Revisions

Title 8 Device Remote		
Size B	Number 6002	Rev A
Date 6–10–03		Drawn by W. Raper
Filename		Sheet of

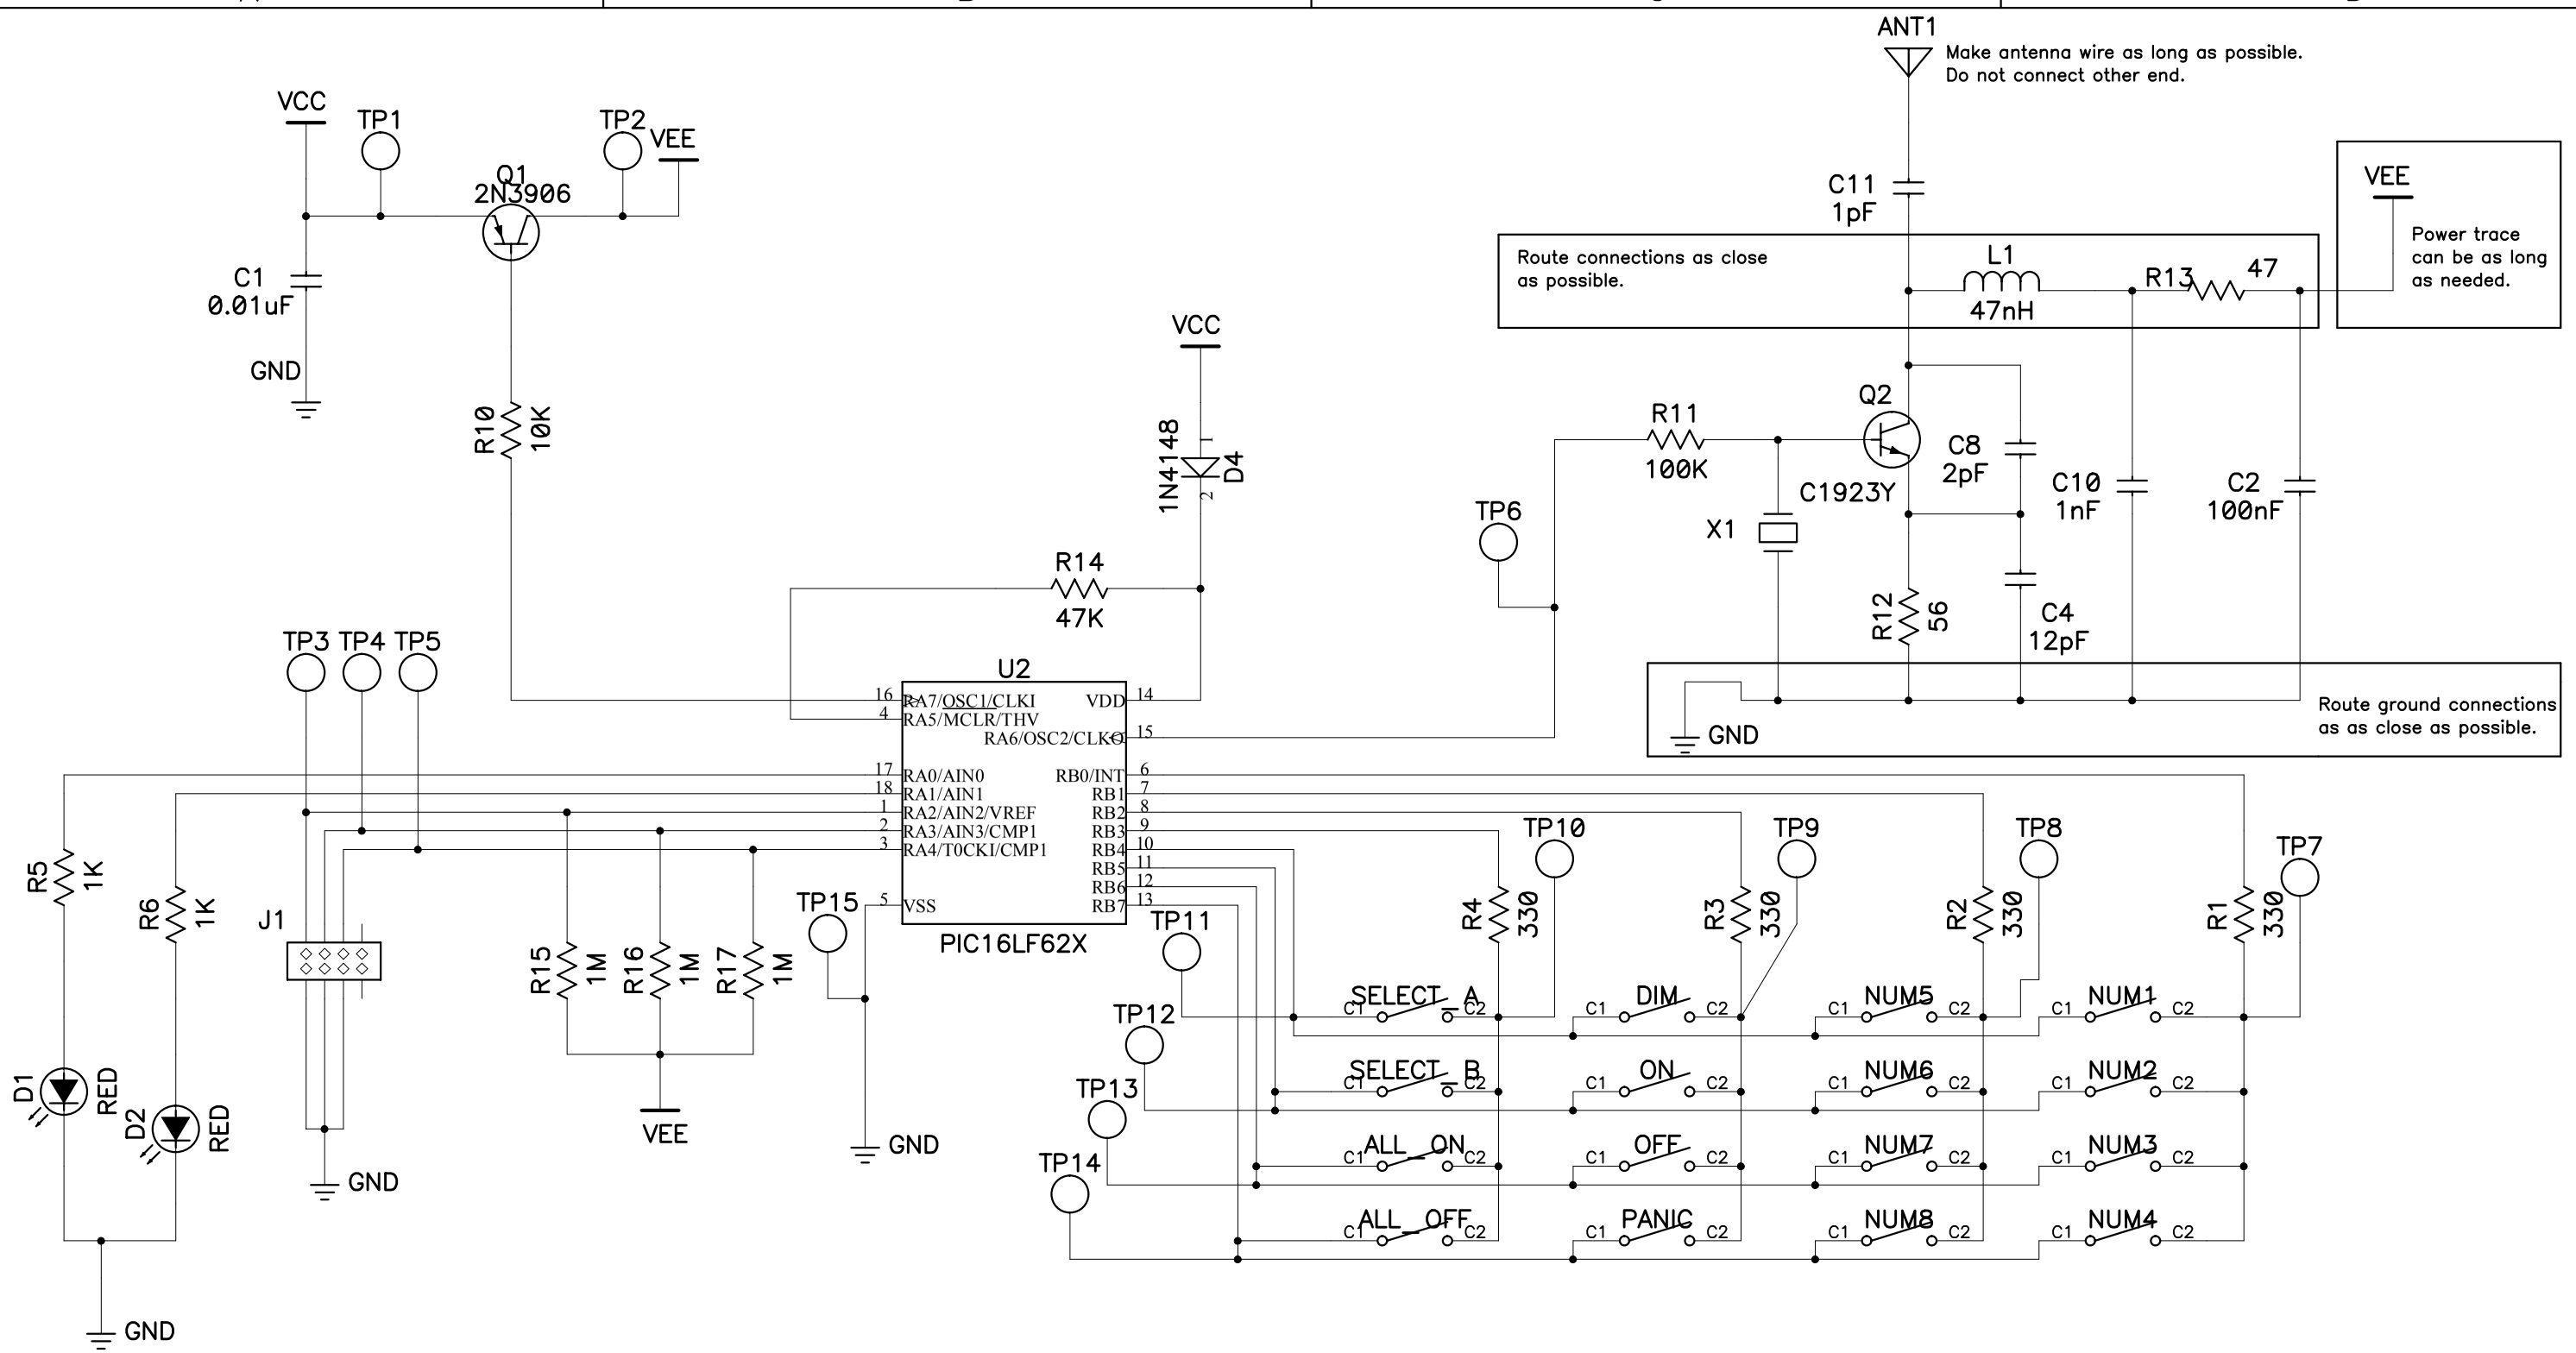
Rev. A: Release to production. Note changes from preliminary.
C4 was 22pF, C8 was 4pF, C9 was 2pF, R11 was 27k,
R12 was 220, L1 was 27nH.

Rev. B: C1 was 10uF, Removed C3, C9
